Subject: UniStar Nuclear Energy, NRC Docket No. 52-016
Response to Request for Additional Information for the
Calvert Cliffs Nuclear Power Plant, Unit 3,
RAI No. 253, Seismic System Analysis

**RAI 253 Question 03.07.02-46 for the ESWB and EPGB, and
Questions 03.07.02-49, 03.07.02-50 and 03.07.02-51
Seismic System Analysis**

Calvert Cliffs Nuclear Power Plant Unit 3

Figure 11. Plan View – Basement Wall Locations - ESWB

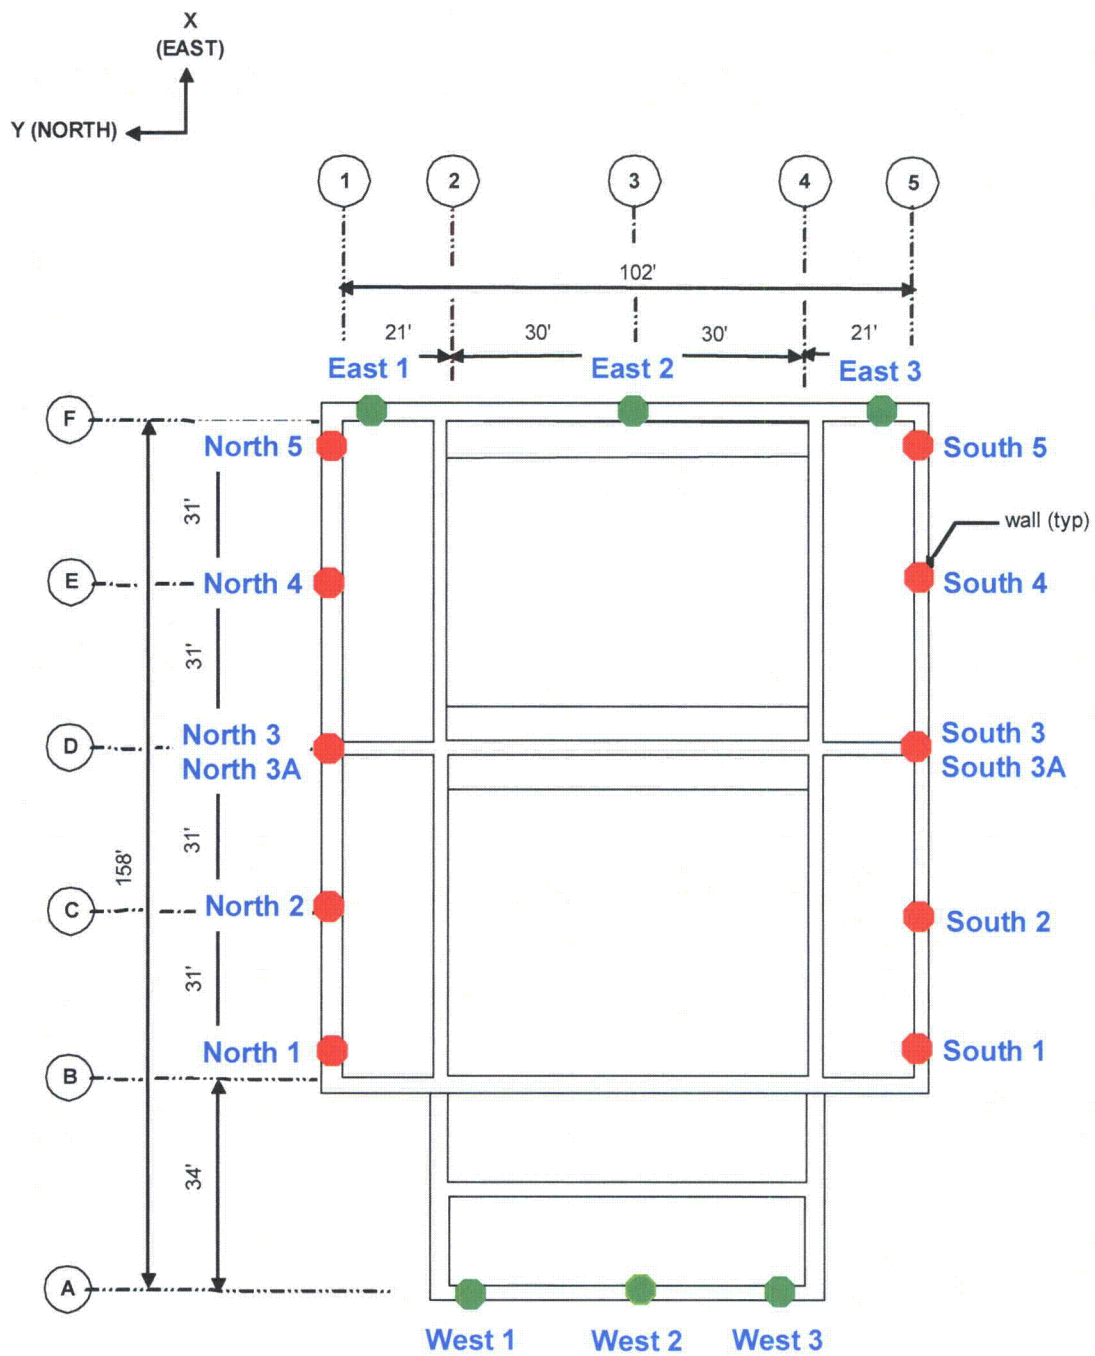
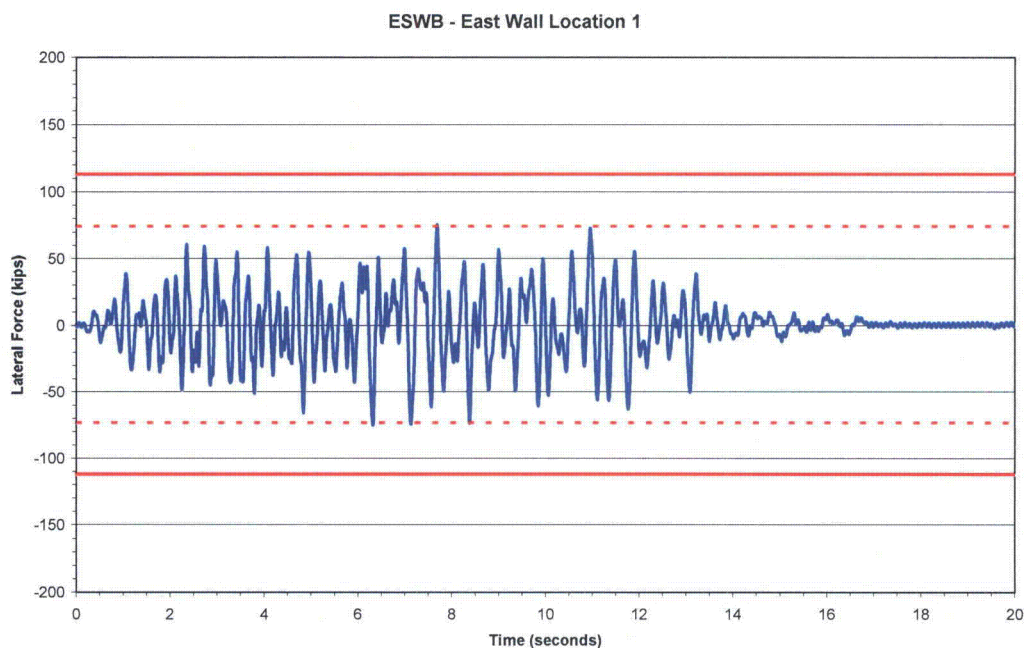
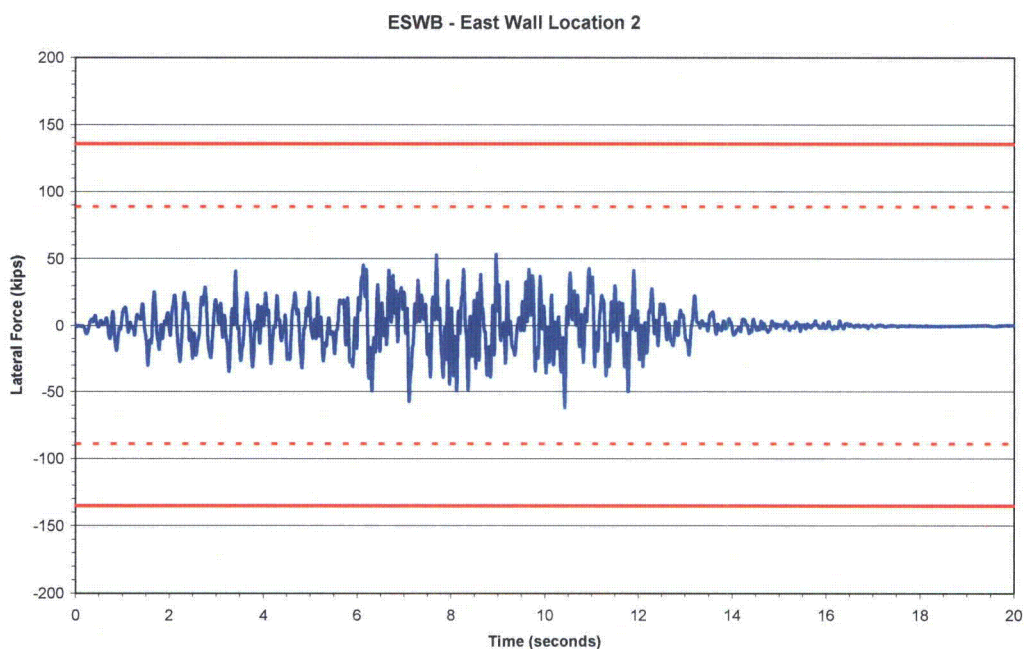
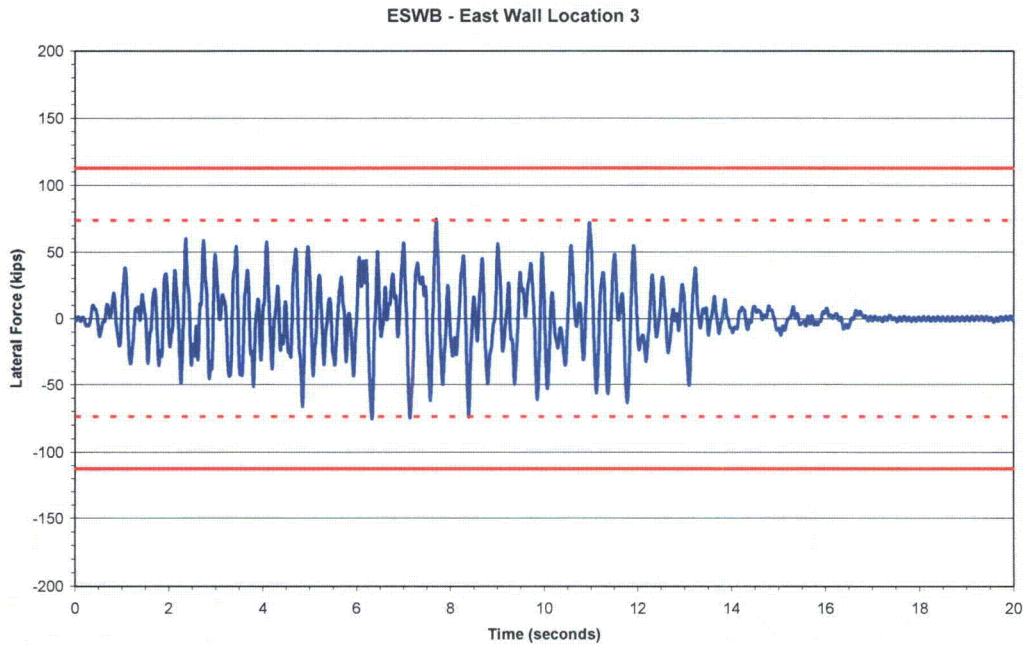
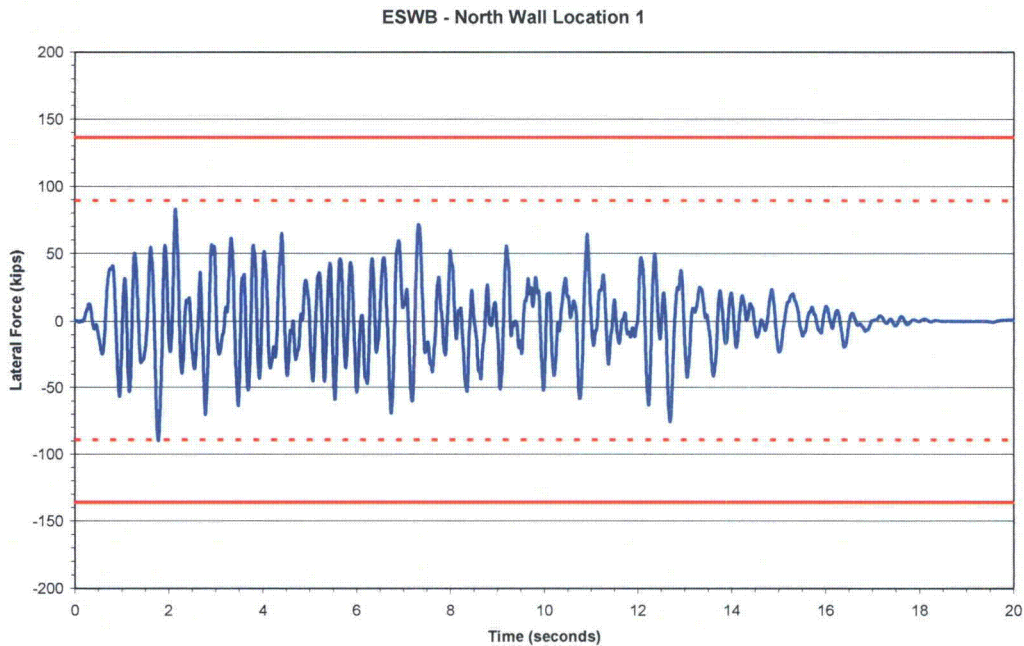
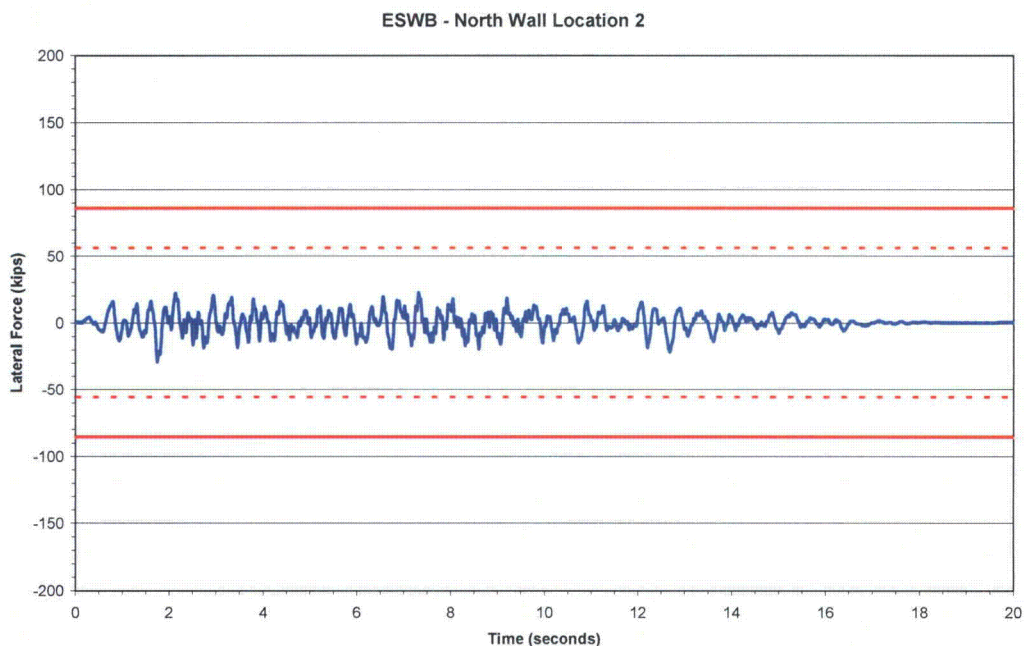
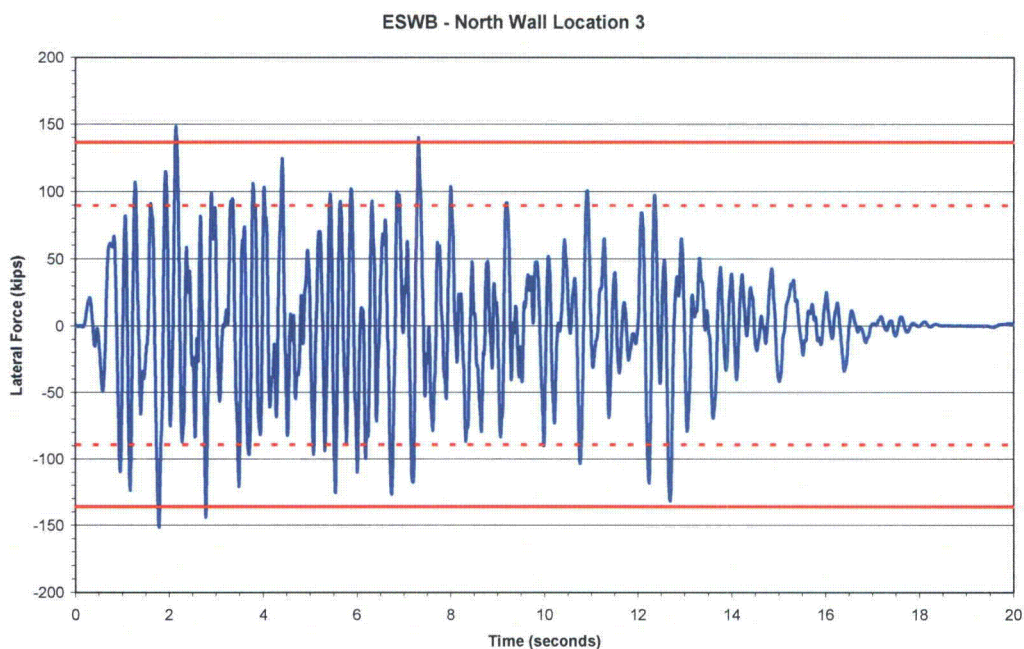
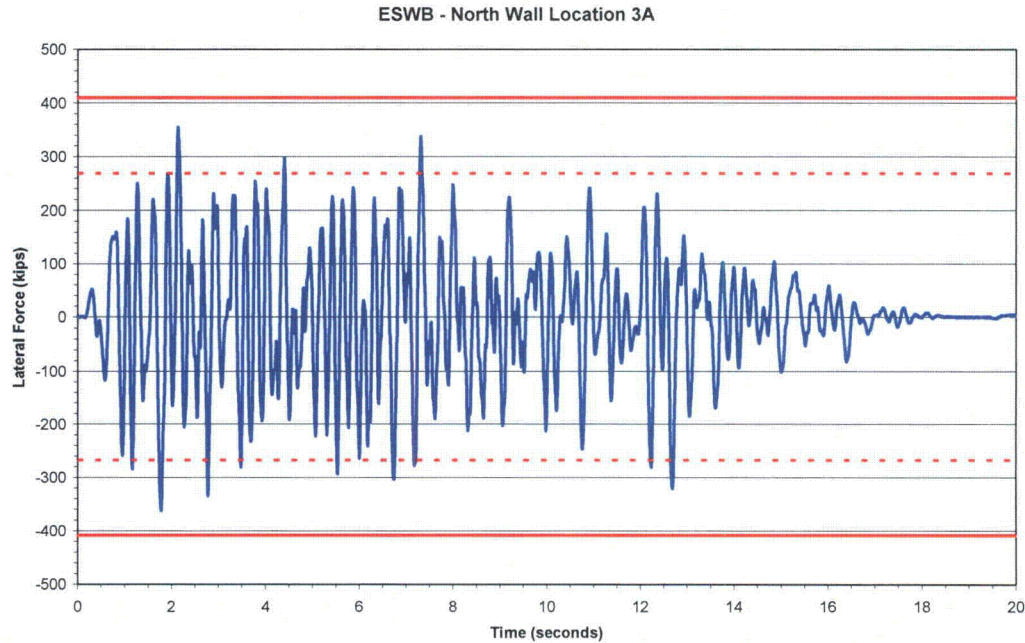
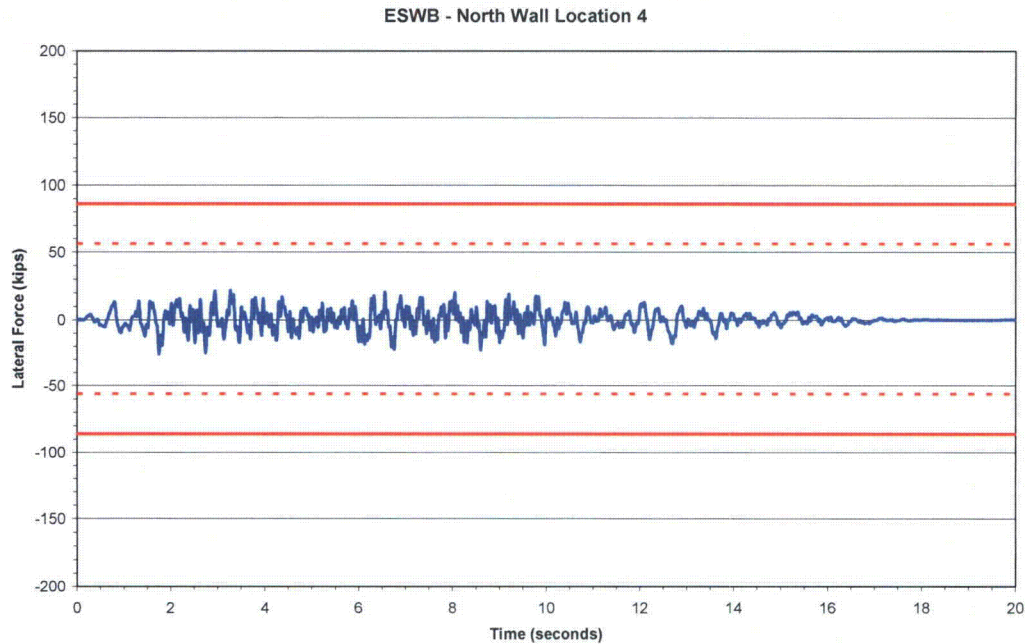
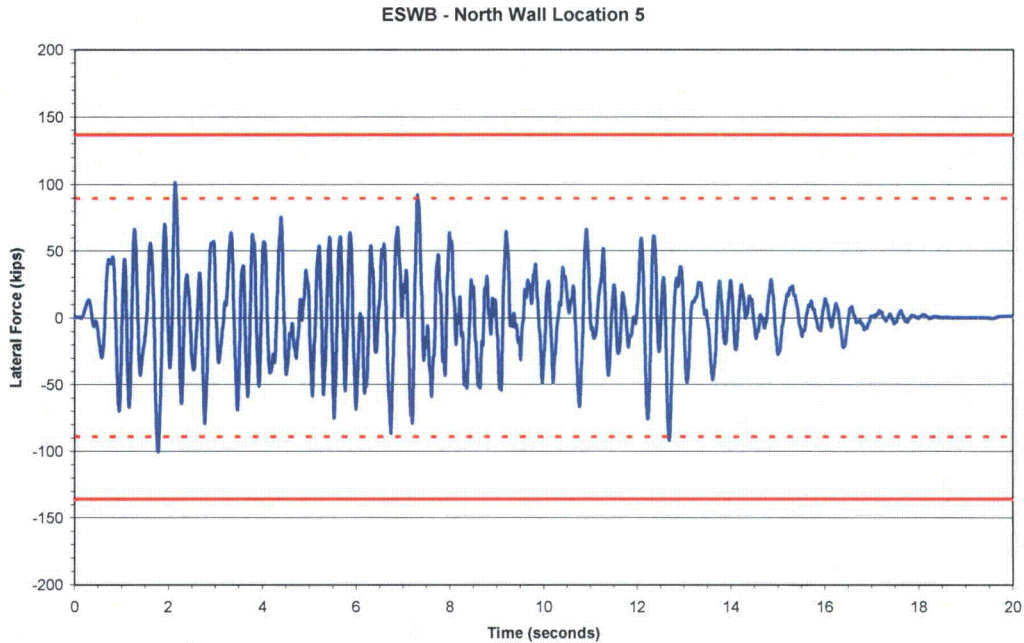
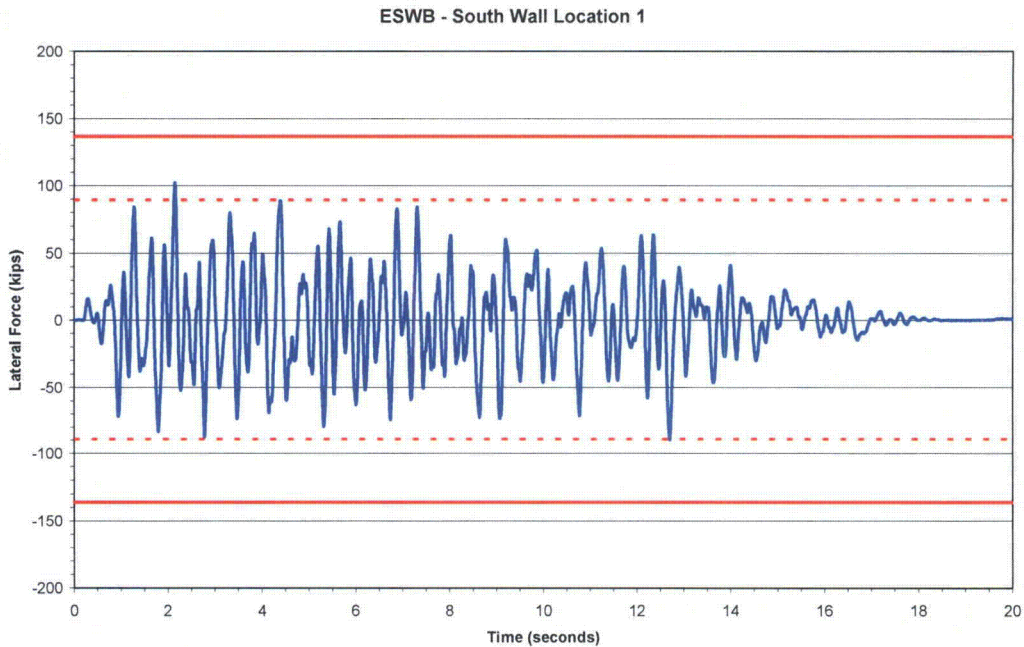
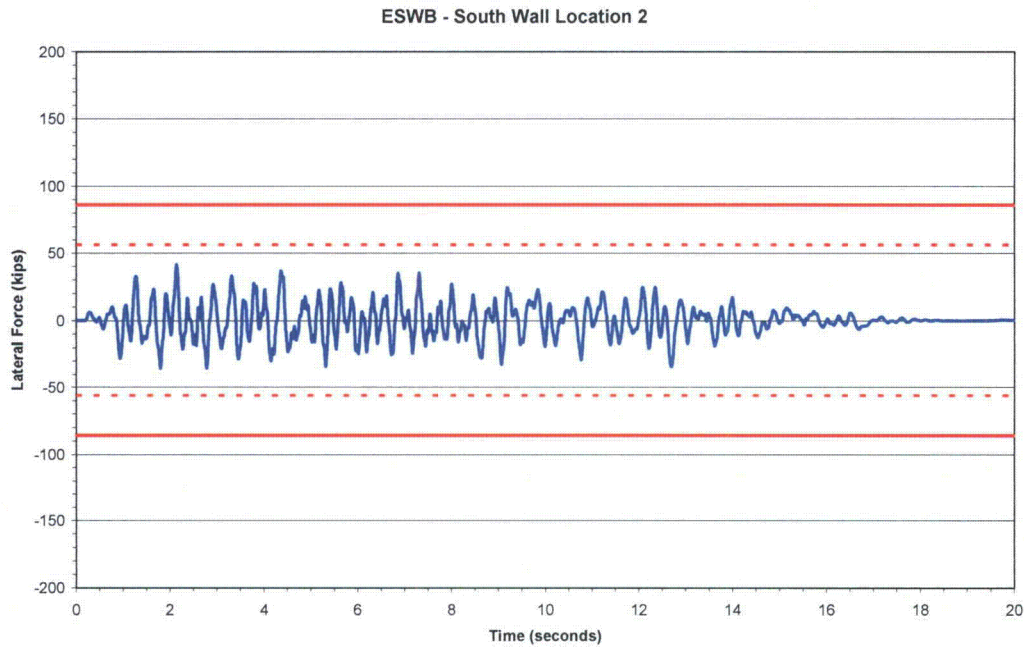
It is not clear how static and dynamic lateral earth pressures were determined in the analysis and how they contribute to the overturning and sliding factors of safety for the structures. The applicant is requested to provide a description of how lateral earth pressures were determined and if tensile soil forces are indicated between the building sidewalls and the soil to describe how these were treated in the overturning and sliding analyses.

To determine if there is separation between embedded exterior side walls and the surrounding soil, total spring forces of a vertical strip of the exterior wall (in the normal to the exterior wall direction) from the SSI analysis of the controlling upper-bound soil case are compared to the static lateral soil pressure. These total spring forces are calculated using the same approach as those used in the above summation of net vertical spring forces below the basemat. It is noted that this evaluation is performed for the ESWB only since the EPGB is a surface founded structure without embedded walls. The static lateral soil pressure is obtained by estimating compaction-induced earth pressures from the grade down to a depth that equates the at-rest soil pressure and then by following the at-rest soil pressure to the embedment depth of the embedded walls. No water pressure is applied since the post construction ground water level is approximately 30 ft below grade, which is below the basemat of the ESWB.

The comparisons at various selected locations of the ESWB (see Figure 11) are shown in Figure 12 through Figure 29. In these figures, solid red lines are static compressive soil pressure (force) for the tributary width of the sidewalls, based on the static soil pressure used for structural design of the embedded walls; and dotted red lines are a lower bound estimation of the static soil pressure (force) for reference. It is noted that Figure 17 and Figure 18 show comparison at the same location (see Figure 11), with Figure 18 (North 3 A) representing a wider tributary width of the basement wall. Similarly, Figure 23 represents a wider section of the south basement wall than Figure 24.

These comparisons show that there is only a limited number of exceedance where the tension forces between the wall and the soil are higher than the static lateral soil pressure (force). These exceedances are highly localized and very short in duration. Therefore the effects of soil separation at the basement walls on the results of the ESWB SSI analyses are concluded to be negligible and the embedded exterior walls are considered to be always in contact with the side soil.
